## **Important CarProg hardware modifications**

Don't forget to make these 4 CarProg hardware modifications:

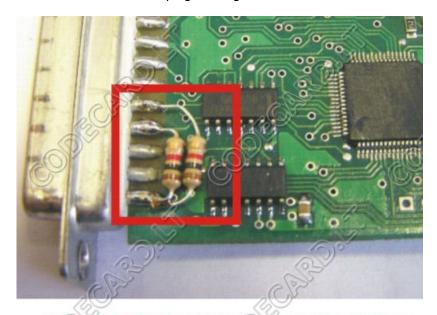
1. Open CarProg and change resistor marked 2R2 to resistor 0R0 or simple bridge like in picture. This hardware modification will improve external power current checking (message "external power consumption is more than 500mA):
